Amendment Notice 2

Licence Number	L6868/1989/12
Licensee	Billabong Gold Pty Ltd
ACN	613 900 922
File Number:	DER2014/001259
Premises	Plutonic Gold Mine Mining tenements M52/171, M52/170, M52/148, M52/149, M52/150, M52/295, M52/296, M52/301 and M52/300 MEEKATHARRA WA 6642
Date of Amendment	31/01/2018

Amendment

This notice is limited to an amendment to authorise an emission point to surface water (W2) and update the ambient groundwater monitoring program. No other changes to the aspects of the Existing Licence or Amendment Notice 1 relating to Category 5, 6, 52, 54, 57 and 89 have been requested by Billabong Gold Pty Ltd (Licensee).

Figure 1: Salmon Pit Lake pipeline and proposed discharge point

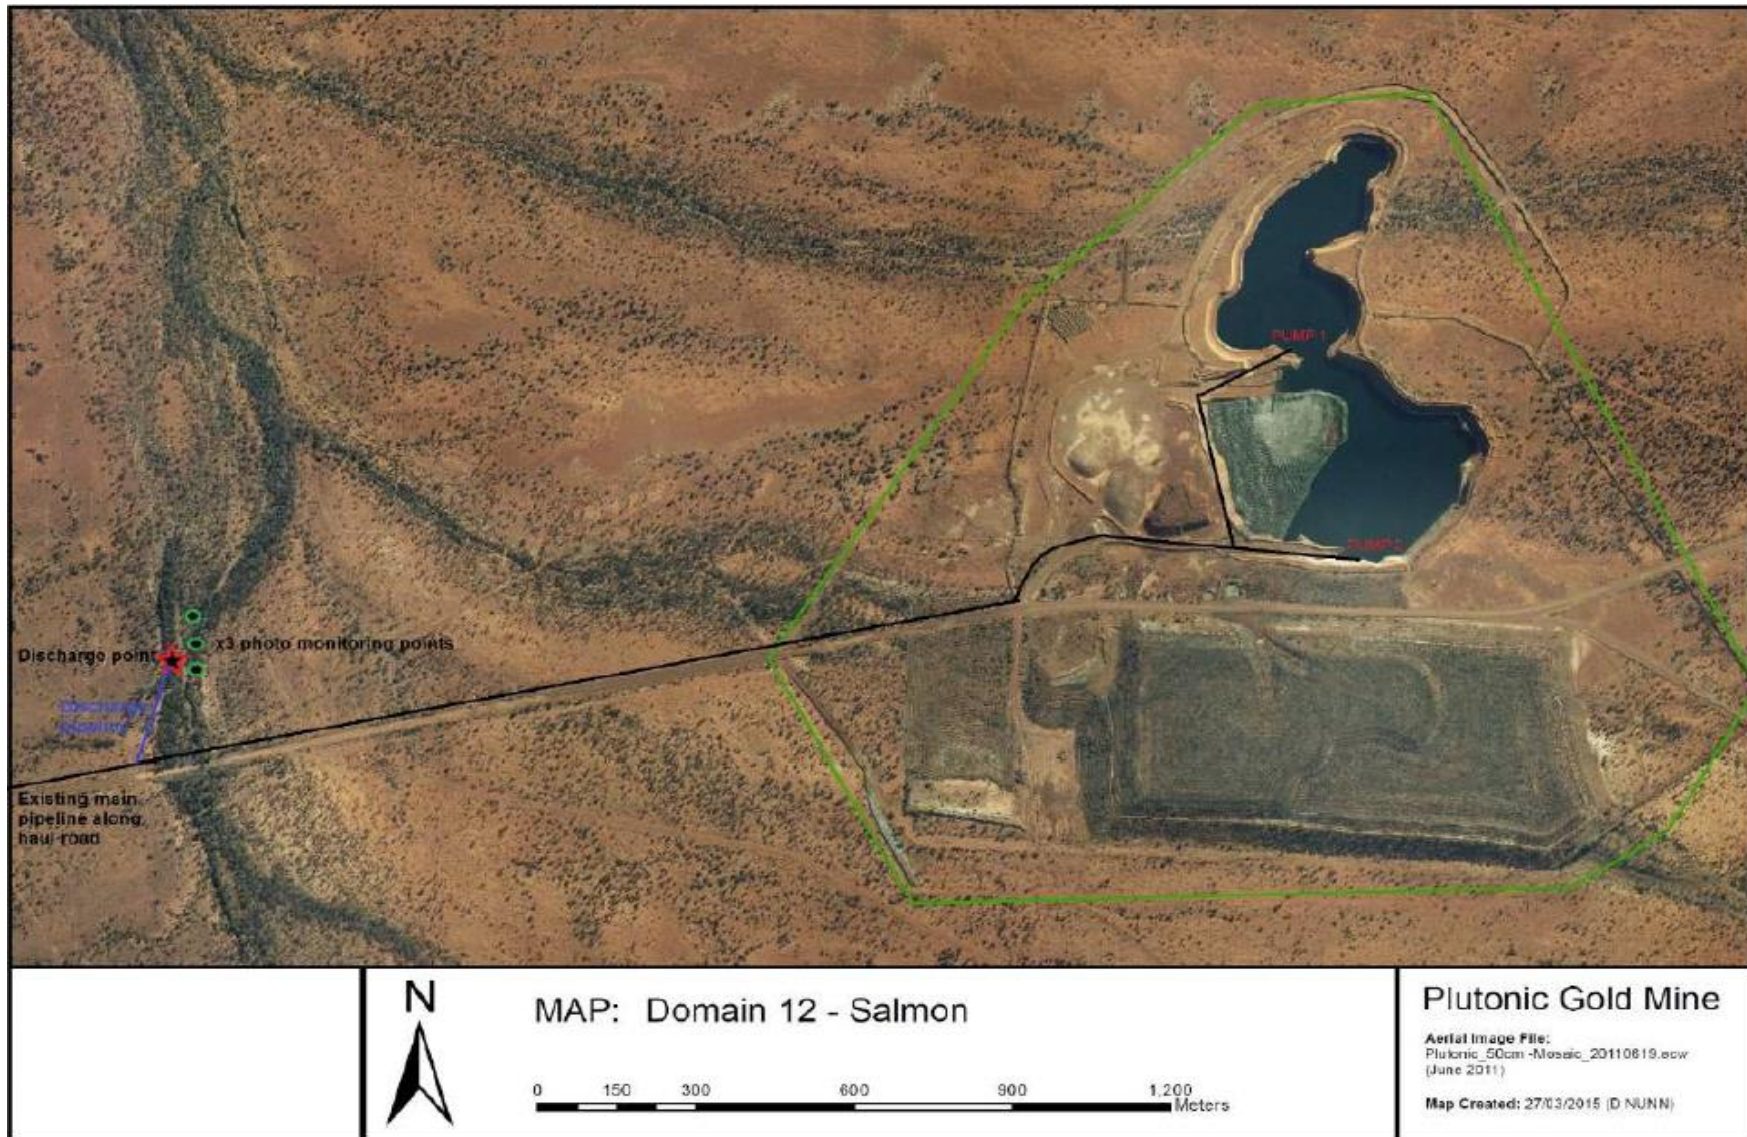
1. Disposal of water from the Salmon Pit Lake to an ephemeral creek-line

The Salmon Pit Lake currently holds approximately 5,300,000 kilolitres (kL) of water, predominately from rainfall events, with an underlying spring also thought to contribute to the pit lake (BG, 2017b). The Licensee is proposing to discharge 50 to 110 litres per second, equating to up to 9,500 kL per day and 3,467,500 kL per year of water from the Salmon Pit Lake to an ephemeral creek-line over a 12 to 18 month period.

The disposal of the pit water will be a controlled discharge into a nearby creek-line at a downstream point located approximately 2.3 kilometres (km) to the west of the Salmon Pit. The purpose of the removal of the pit water from Salmon Pit is to enable the feasibility of re-opening the Salmon Pit area for mining to be assessed, while ensuring the upcoming wet season rainfall events during summer (peak period January to March) do not fill the Salmon Pit further.

The Laterite Pit Lake water storage reservoir receives all the Premises return water (e.g. Main Pit underground dewatering, processing / TSF return water, etc.) and Salmon Pit Lake water as required. The main pipeline from Salmon Pit Lake to the mine water circuit (Laterite Pit) already exists as Salmon Pit Lake is used as a supplementary water source at the Premises if required (currently used for dust suppression on the Hermes Project haul road). In order to cater for the discharge of pit water from the Salmon Pit Lake to the proposed discharge point the main pipeline requires the installation of a discharge pipeline (150 m in length) off the main pipeline (i.e. T-valve). The discharge pipeline will have a valve connection at entry point into the creek-line. Figure 1 shows the location of the Salmon Pit Lake and pipework route to the proposed discharge point.

The key emission associated with the discharge of pit water from the Salmon Pit Lake to the creek-line is discharges to surface water. The Delegated Officer considers the risk associated with this emission to be *medium*.

- Inclusion of the discharge point (W2) in condition 2.2.1 for the discharge of pit water from Salmon Pit Lake to the creek-line;
- Condition 3.2.1 has been updated to include the requirement for the Licensee to undertake water quality monitoring of the discharge water through W2 (when discharging) and record the volume of water discharged to the creek-line; and
- Condition 3.5.1, Table 3.5.2 has been updated. The Licensee is required to undertake quarterly photographic vegetation monitoring across the zone of influence of the discharge from W2 at three monitoring points (V4, V5 and V6). The Licensee has also committed to undertaking visual monitoring of the riparian vegetation on a weekly basis to ensure soil saturation and water logging does not occur (BG, 2018).

Figure 2: Site layout including location of historic in-pit TSFs

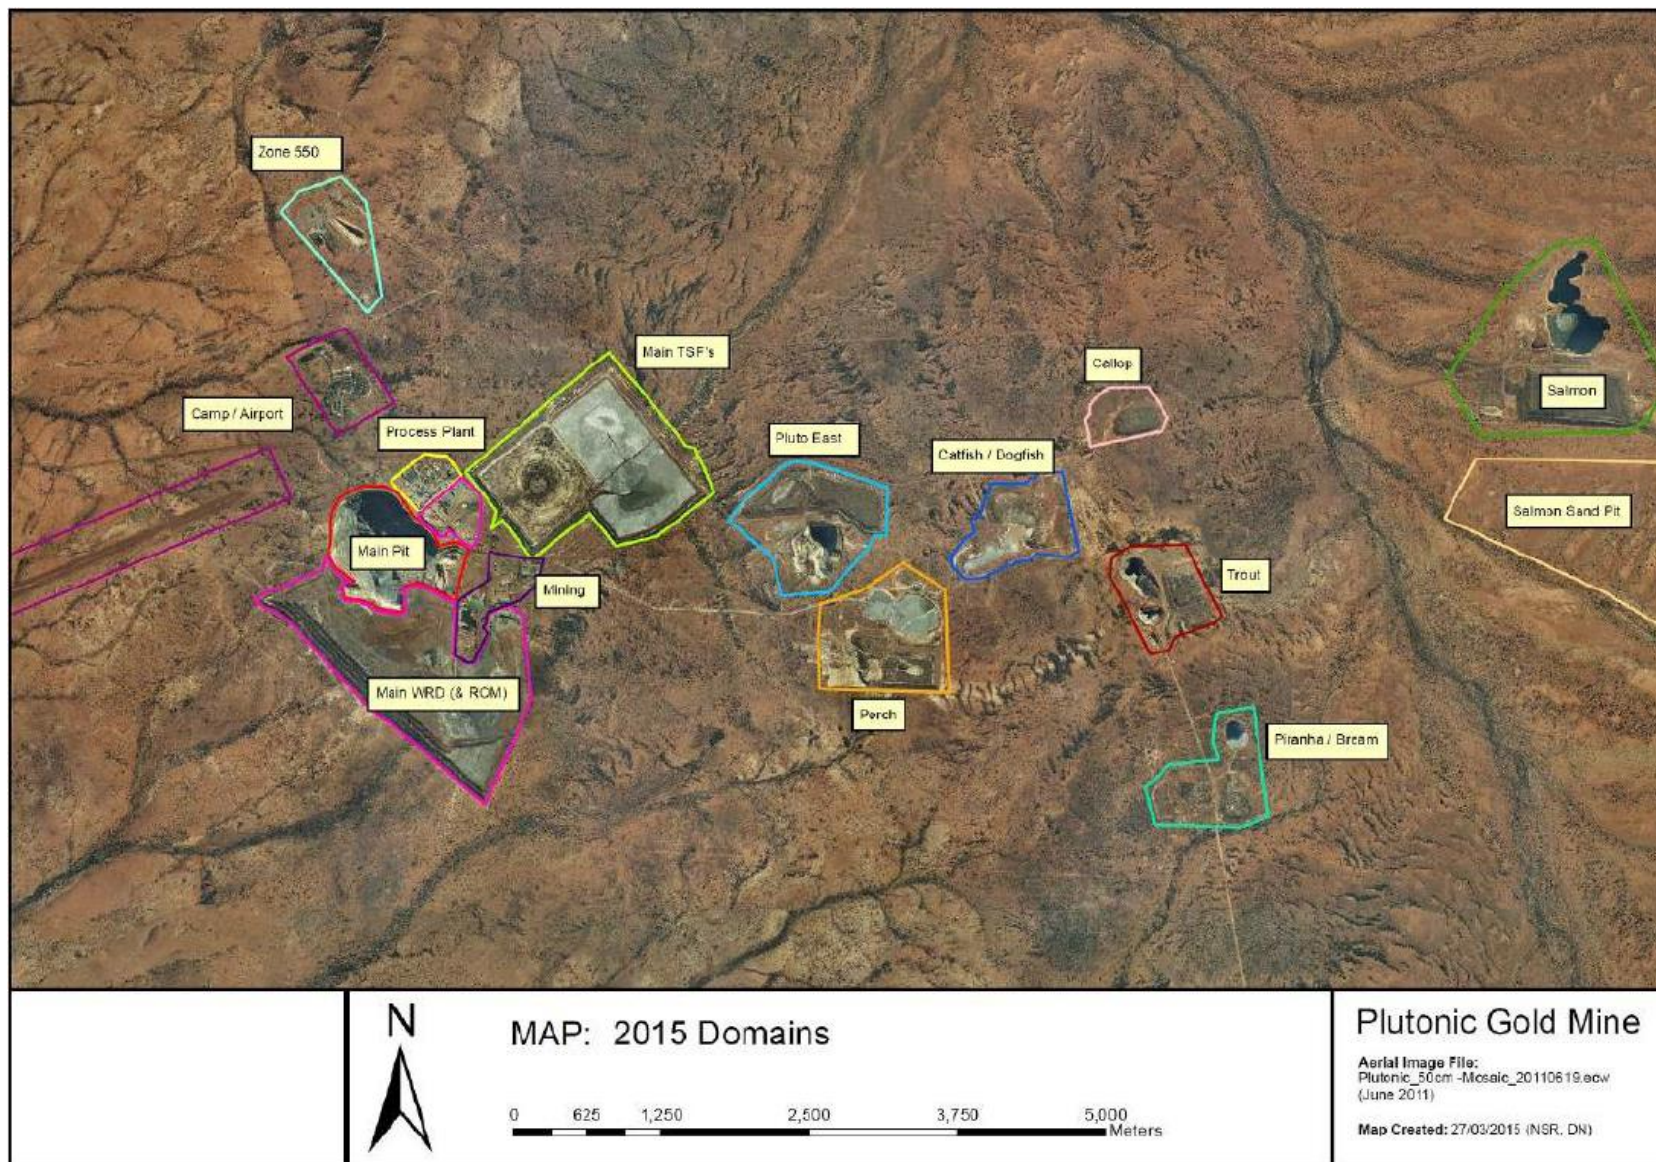
2. Removal of ambient groundwater monitoring bores associated with inactive in-pit TSFs

The Licensee has requested that all water monitoring bores for historic in-pit TSFs (Callop, Dogfish, Perch, Catfish, Piranha and Trout as shown in Figure 2) be removed from Table 3.5.1 of the Existing Licence and Amendment Notice 1.

The Licensee has stated (BG, 2017c) that they have “*completed the capping and rehabilitation of the in-pit TSF’s in 2017 and thus the bores and access tracks to them require removal to completely rehabilitate these areas under the Plutonic Mine Closure Plan*”.

IR1, 2017 states that the Perch and Catfish TSFs were capped on 23 March 2017 and the Annual Environmental Report (AER) for the 2017 reporting period (AER 2017) also states that monitoring bores for the Piranha in-pit TSF and Trout in-pit TSF (PIRMB5, PIRMB6, TRTMB1 and TRTMB2) have been removed following capping of in-pit TSF and rehabilitation on entire areas.

DWER has reviewed the tabulated groundwater data for the following bores covering the period March 2015 to November 2017 (AER 2015, AER 2016 and AER 2017):

- CMB1, CMB2, and CMB3 (Catfish);
- PMB56, PMB64, PMB67 and PMB72 (Perch);
- DMB2 and DMB3 (Dogfish);
- CLMB1, CLMB2, CLMB3, CLMB4 (Callop);
- PIRMB5 and PIRMB6 (Piranha); and
- TRMB3, TRMB4, TRMB5, TRTMB6, TRMB7, TRTMB1 TRMB8 and TRMB2 (Trout).

The monitoring data indicates that key water quality parameters and metals concentrations in these bores appear to be stable and the analyte concentrations do not indicate any cause for concern. The Delegated Officer has determined that the above bores can be removed from the ambient groundwater monitoring program (condition 3.5.1).

The Licensee will be required to continue monitoring the bores relating to the above-ground TSF cells 2 and 3 (TD1-2, TD1-5, TD2-1, TD2-3, TD3-2 and TD3-7).

Premises map

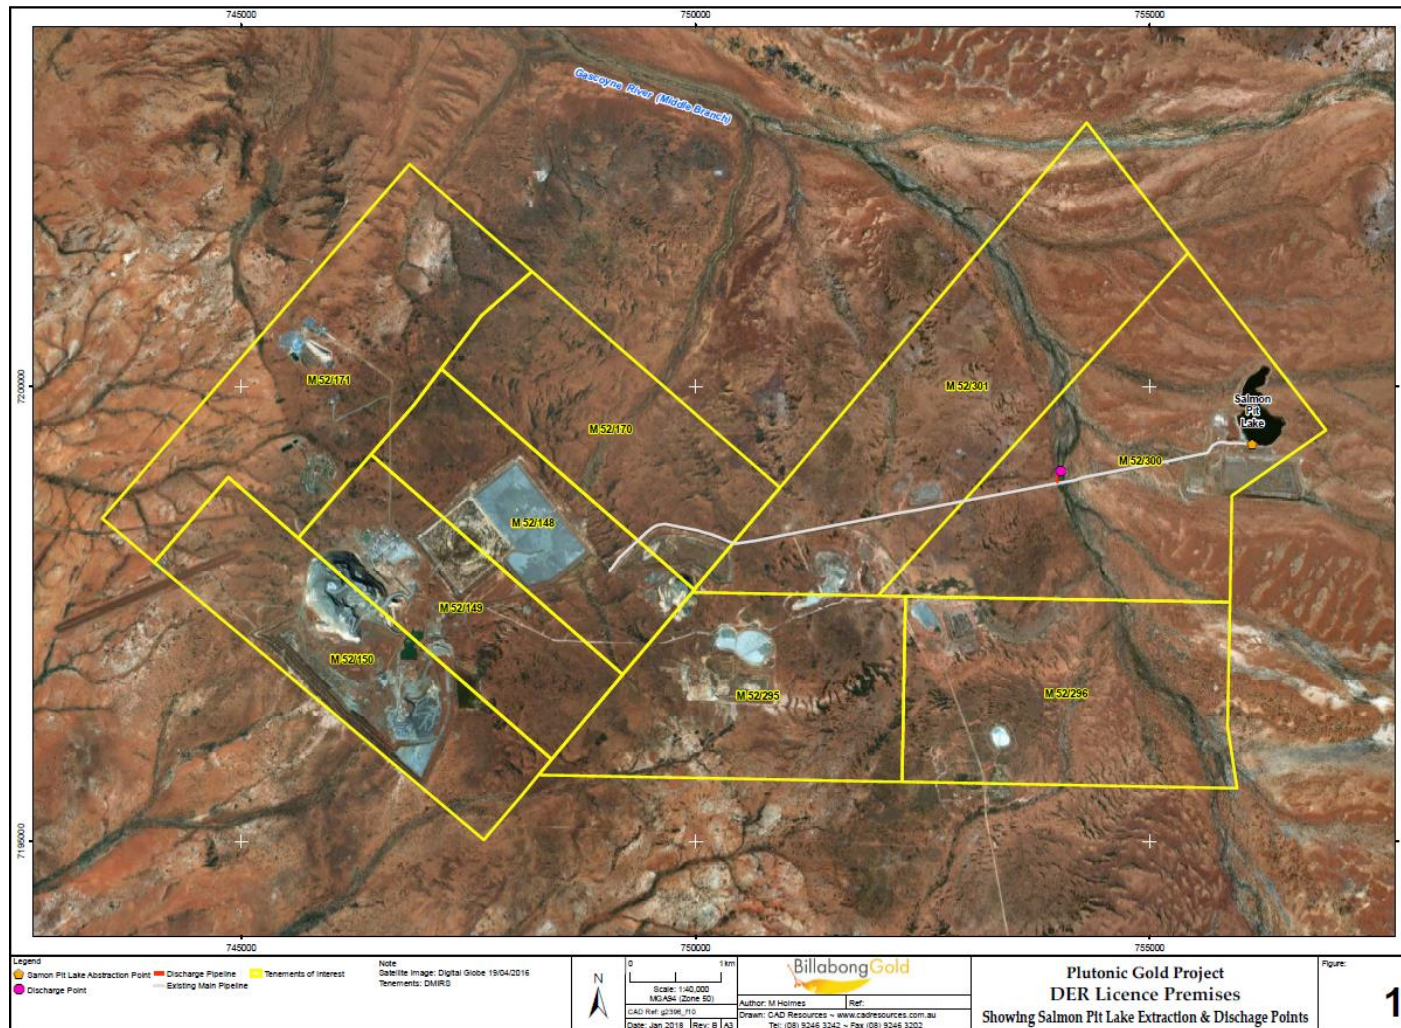
- All references to DER changed to DWER.
- The registered office address has been updated.
- The Premises address has been updated to include tenement M52/300 for the discharge point. The Premises map in Schedule 1 has been deleted and replaced with the map in Attachment 1 of this Amendment Notice.

13. The Premises map in Schedule 1 is deleted and replaced with the map in Attachment 1 of this Amendment Notice.
14. The second map in Attachment 2 has been inserted via this Amendment Notice.
15. The maps of monitoring locations in Schedule 1 for the “Callop groundwater monitoring bores”, “Callop groundwater monitoring bores with coordinates”, “Perch groundwater monitoring bores”, “Catfish/Dogfish groundwater monitoring bores”, “Piranha groundwater monitoring bores” and “Trout groundwater monitoring bores” are deleted via this Amendment Notice.
16. The WR1 Form in Schedule 2 is deleted and replaced with the form in Attachment 3 of this Amendment Notice.
17. The GR1 Form in Schedule 2 is deleted and replaced with the form in Attachment 4 of this Amendment Notice.

Attachment 2

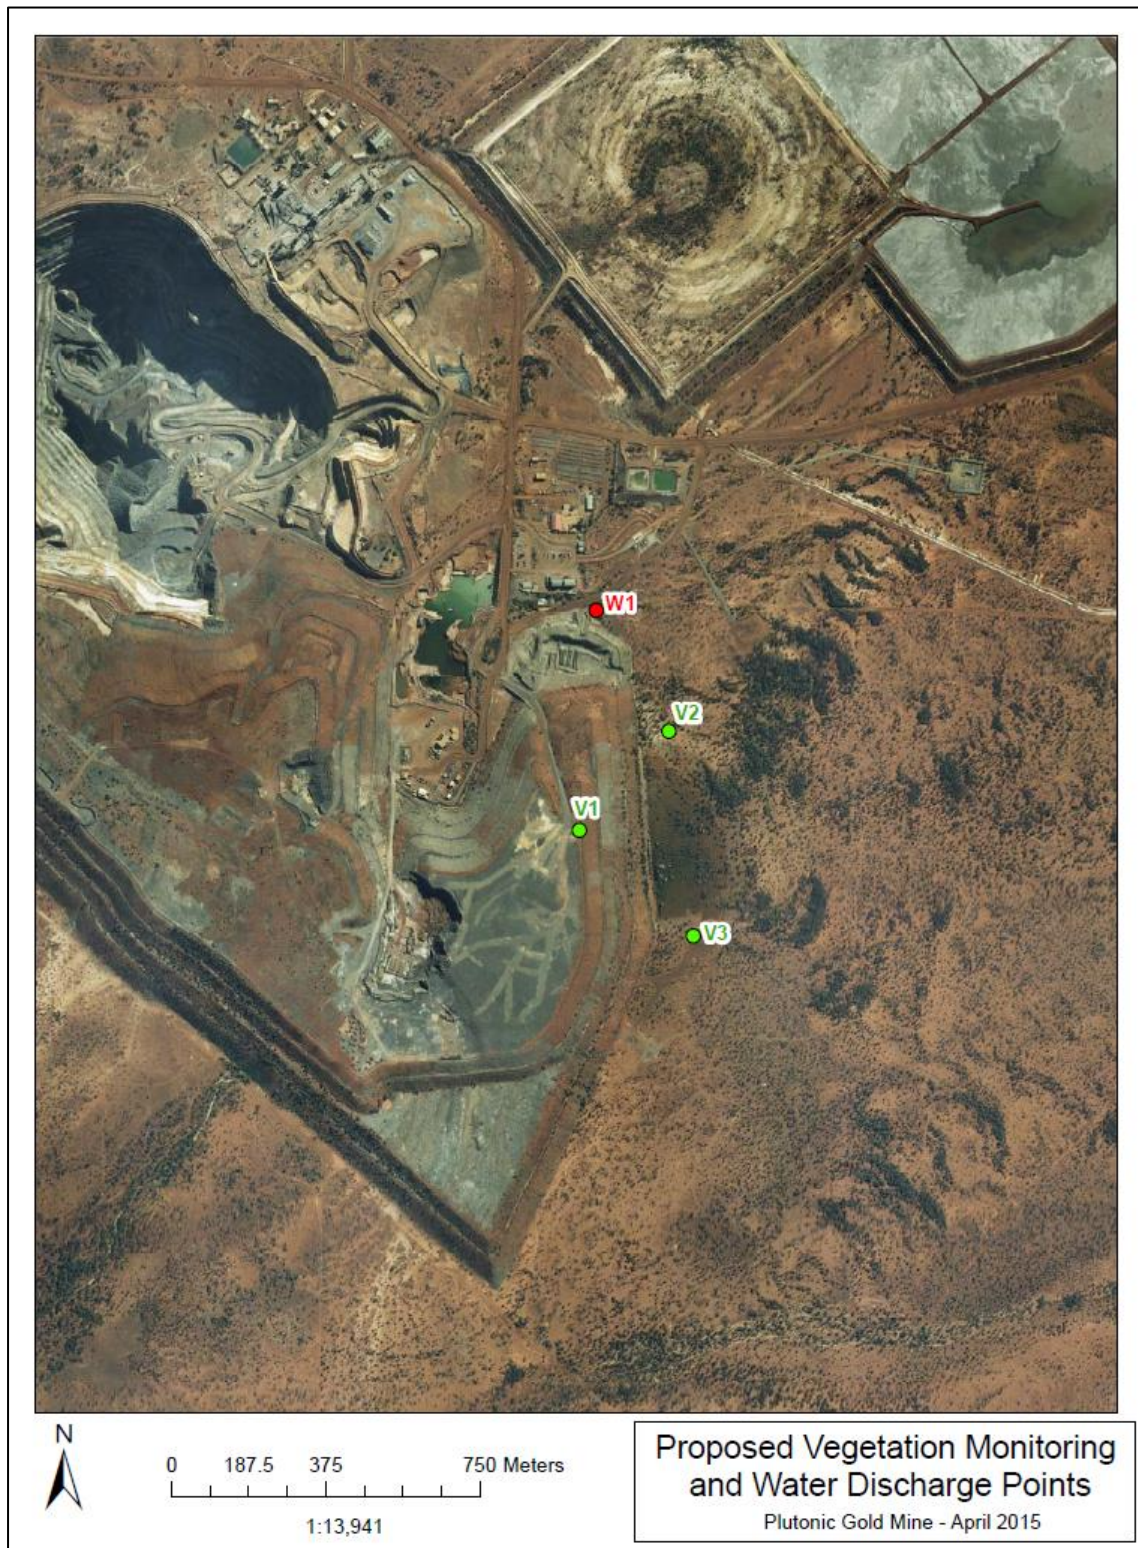
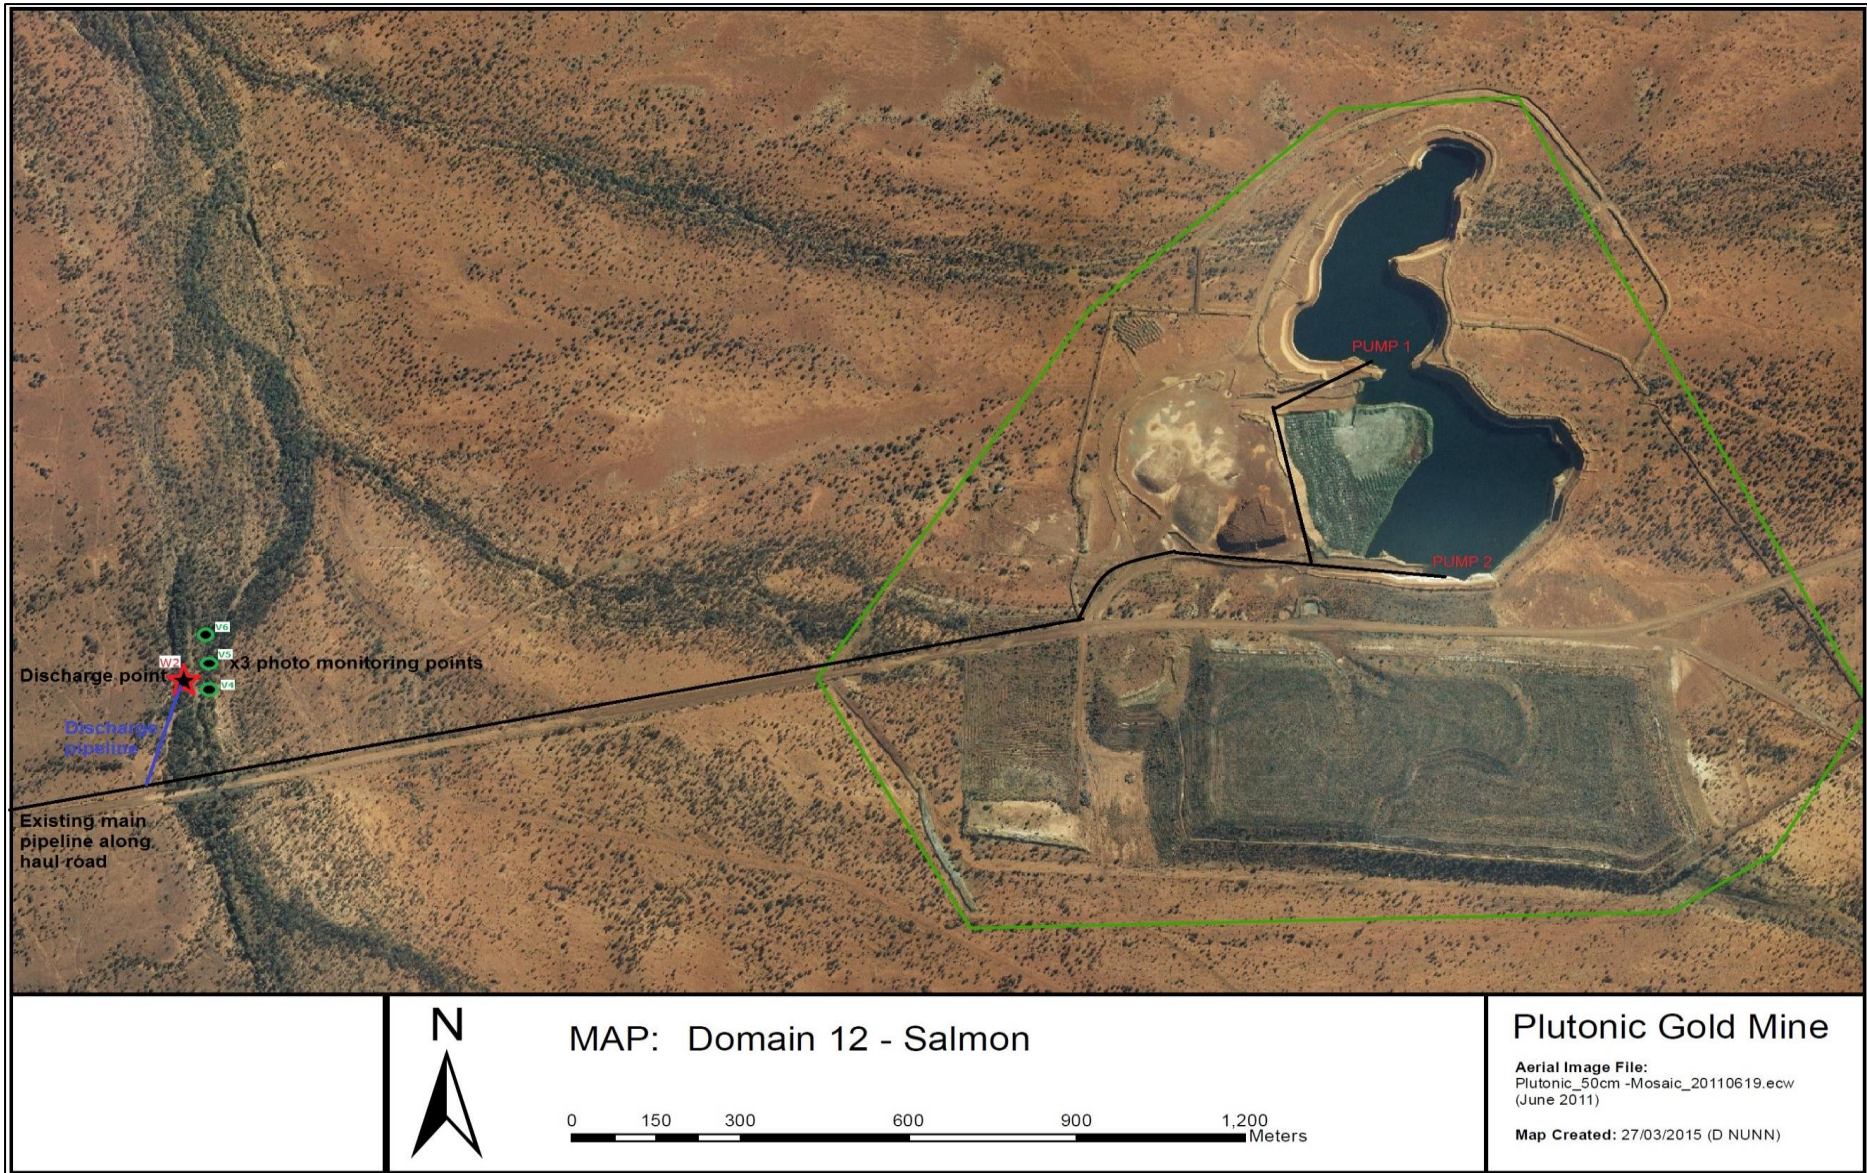
- An additional emission points and monitoring locations map in Schedule 1 for Tables 2.2.1 (W2) and 3.5.2 (V4, V5 and V6) has been added via this Amendment Notice.

The location of the emission points defined in Table 2.2.1 and location of the monitoring points defined in Table 3.5.2 are shown in the two maps below.
